TOLERANCES ± 0·4mm UNLESS OTHERWISE STATED.	MATERIAL		QUANTITY		SCALE	DRAWN	G. BLAIR	DATE	OCT/81
Bridgeport TEXTRON Bridgeport Machines Division of Textron Ltd.	PART	SCHEMATIC DIAGRAM				PART No.	
	MACHINE	SERIES I M.D.I. MILLING MACHINE				DRG. No.	879-100	ISSUE C

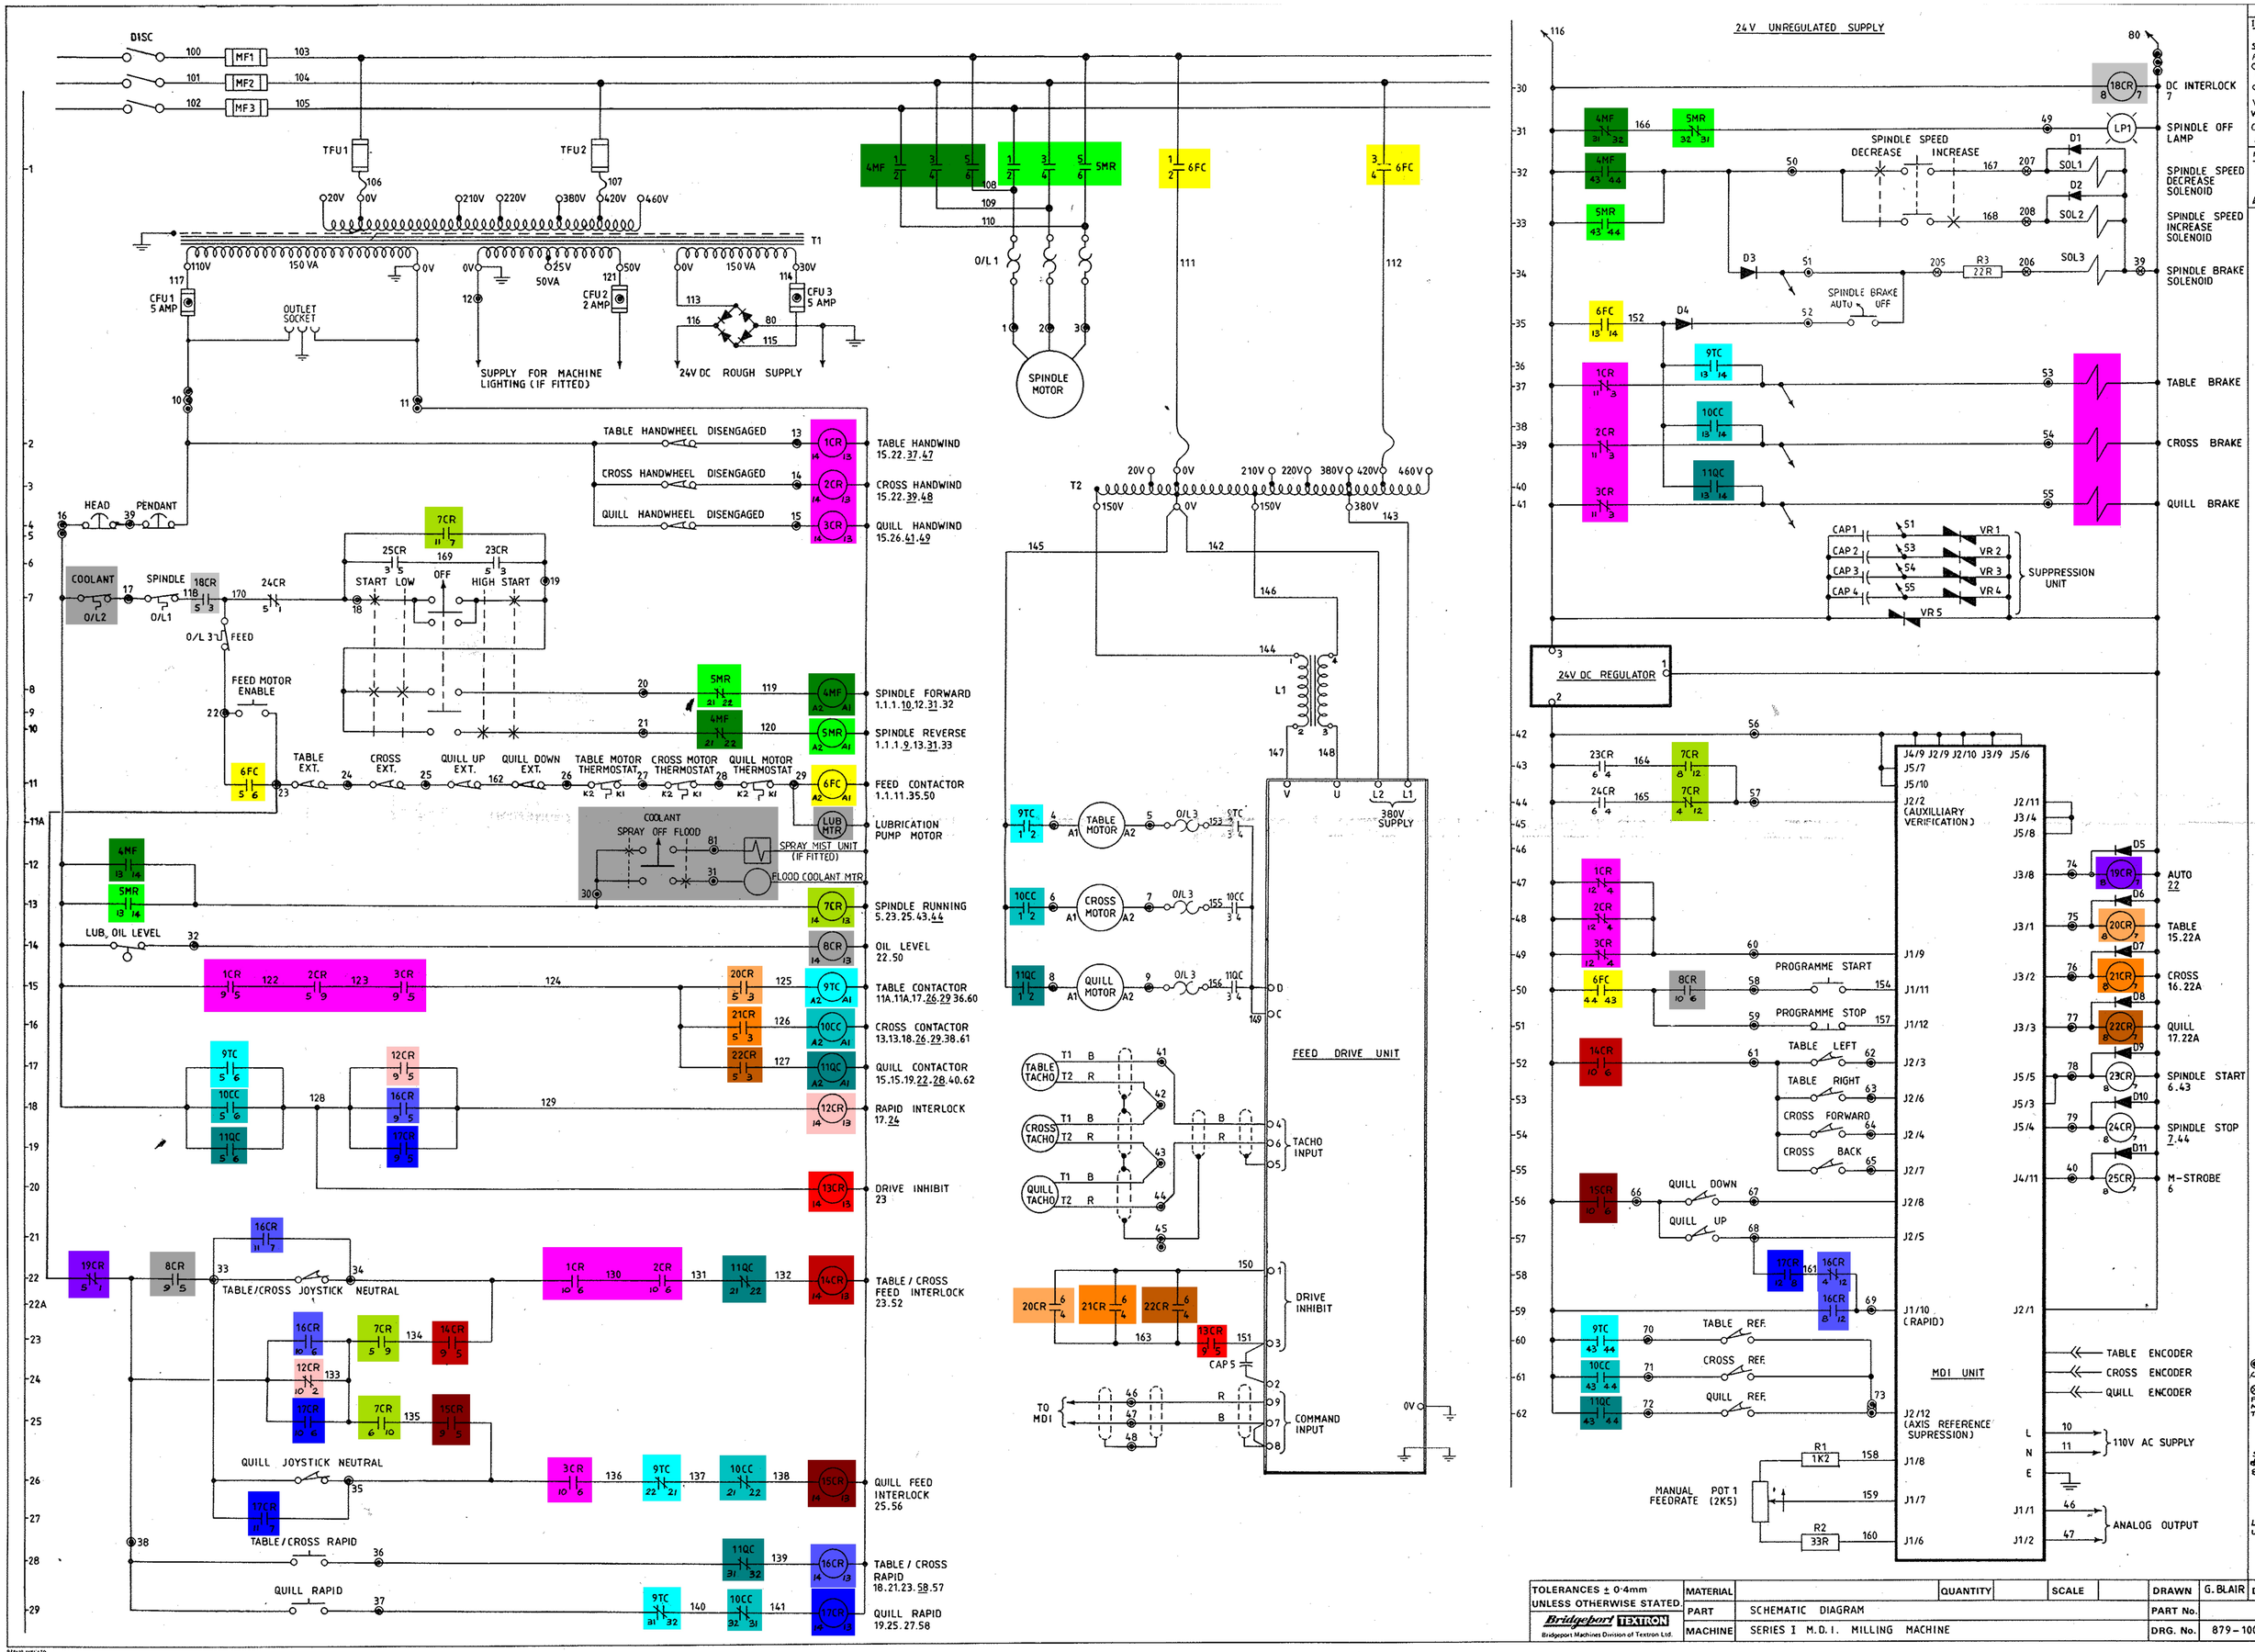
ISSUE B:-
SPRAY-MIST OPTION ADDED TO TERM'L 81. COOLANT SWITCH NOW 3-WAY. O/L3 ADDED.
WIRE TO 19CR5 WAS 16, NOW 23.
OUTLET SKT ADDED
AH 3-12-81

ISSUE C:-
R3 ADDED (REF LINE 34)
AH 24-1-82
